**City of Charlottesville**

**Board of Architectural Review**

**Regular Meeting**

**March 19, 2024, 5:30 p.m.**

Rugby Road Historic District Survey 2014

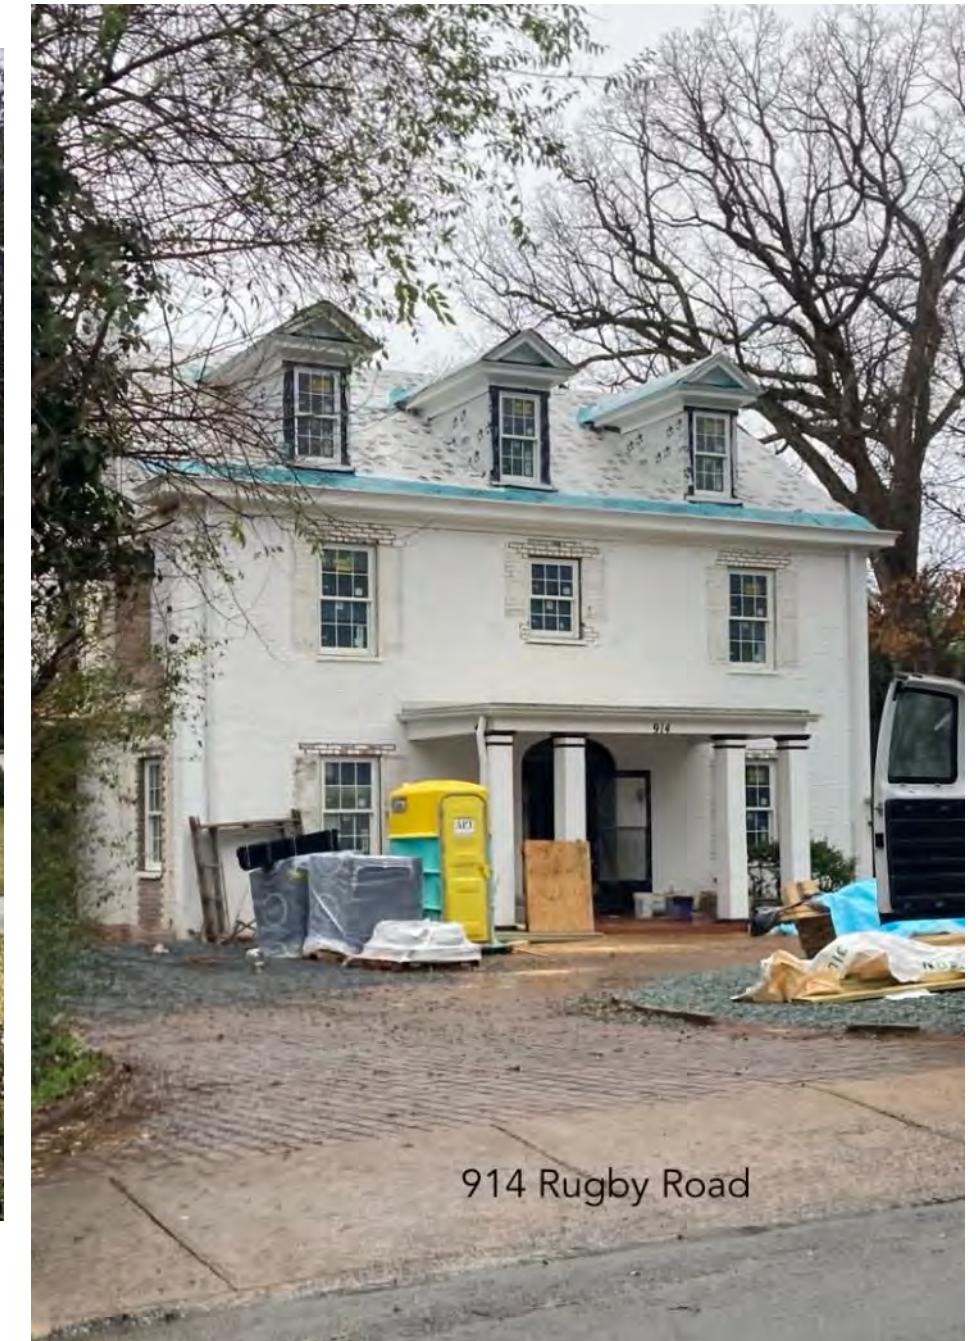
**Staff Comment:** Only the porch roof will be altered. Of the 30+ properties in the Rugby Road HC District, there is no typical style or material for existing roofs in the district. (See attached images See staff comment under Discussion.)

**Staff Comment:** The proposed alteration would retain the exiting existing trim and columns. BAR should discuss if the new roof should be flat-seam metal or if membrane is acceptable.

**Staff comment:** As best we can determine, the primary façade and front porch have not been altered. The proposed alterations will not change the porch trim, columns, and entablature, only the porch roof.

**Staff comment:** The layout and footprint of the porch will not change and the existing columns, trim, porch ceiling, and entablature will remain. Only the roof portion will be altered. With documentation and photographs, the current roof—material, elements, and design—could easily be recreated at a later date.

807 Rugby Road - front portico, BAR review 3-19-2024

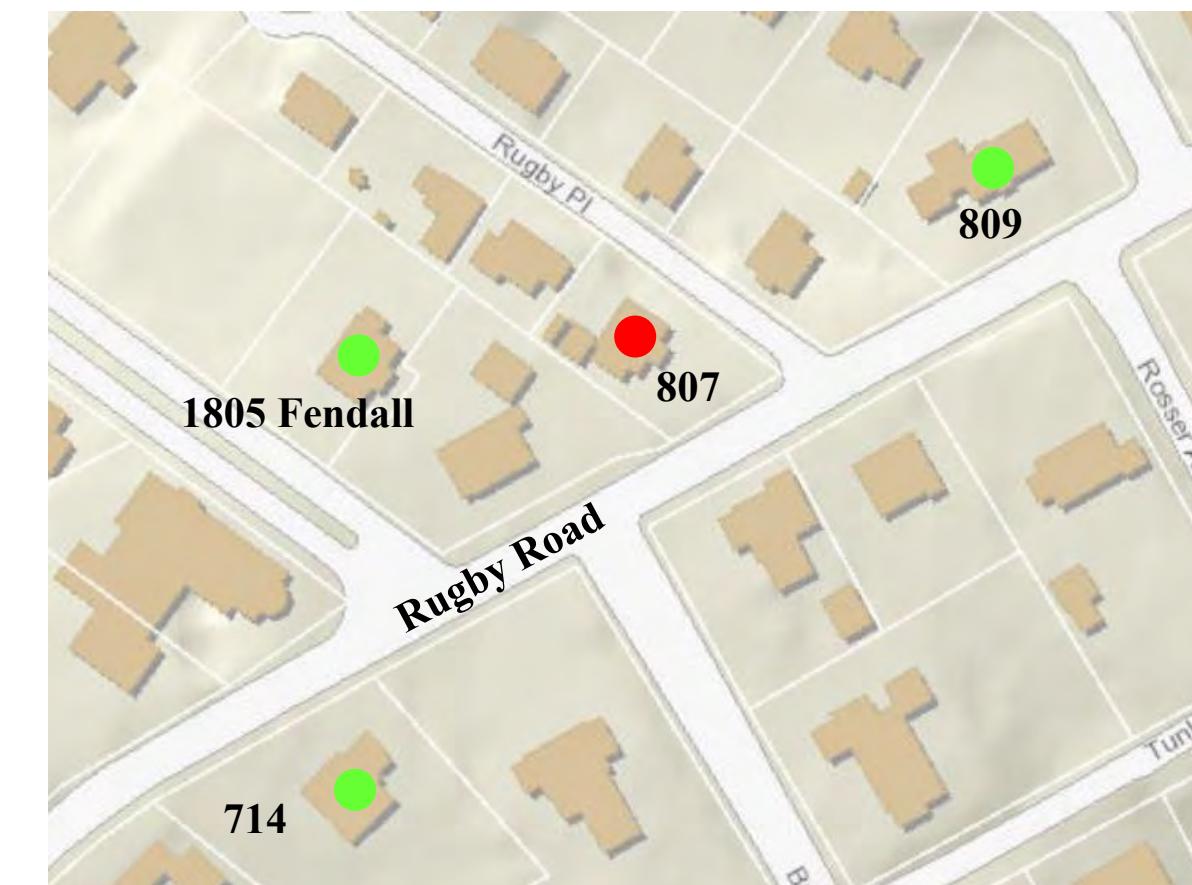
Three similar porches in district.

**Driveway cutout.**

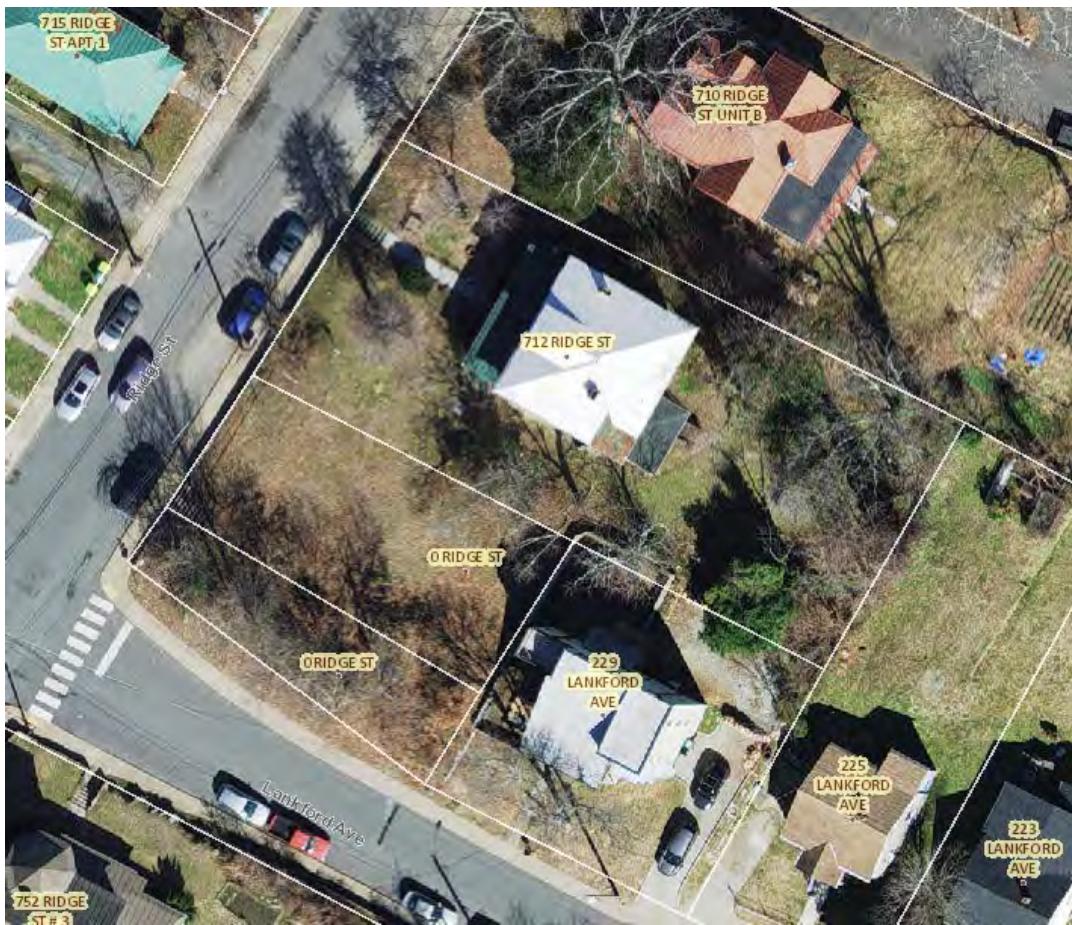
There is currently a retaining wall in front of the property. If we are permitted to cut the curb to install the driveway, we would repair any cuts to the retaining wall and build the new sides as a parged, concrete block wall to match the existing wall. Please find attached several photos and sketches that provide more information on the proposed work. We seek permission to hire a contractor to obtain permits and work with the City of Charlottesville and Dominion Power to move forward with the driveway installation.

**Chimney Removal.**

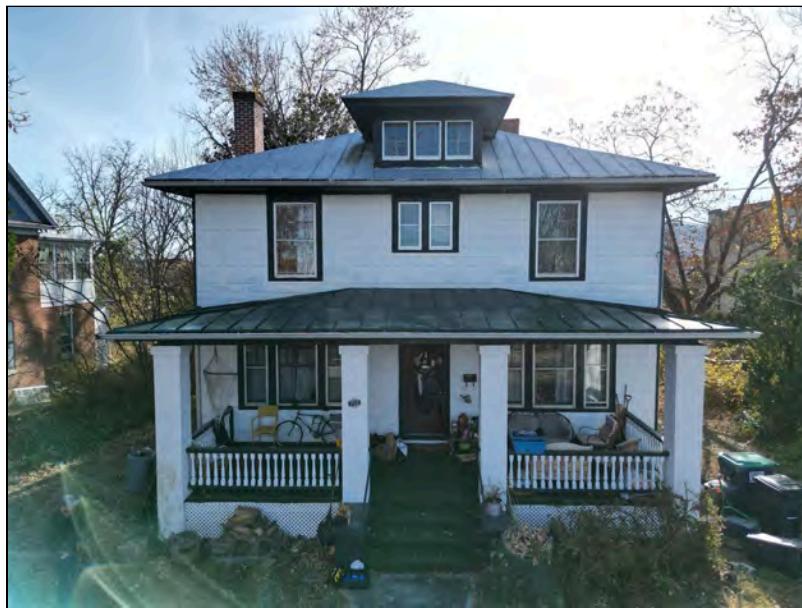
Because the chimney on the right side of the house is dangerous and no longer working, and because there is a prominent (and still functioning) chimney on the other side of the house, we propose hiring a masonry professional to remove the entire chimney from the ground up. Removing the chimney so would save us from having to completely reconstruct a chimney structure that would remain unused and that would take up space in the middle of the right side of the home and that would prevent efficient use of the space inside the home.
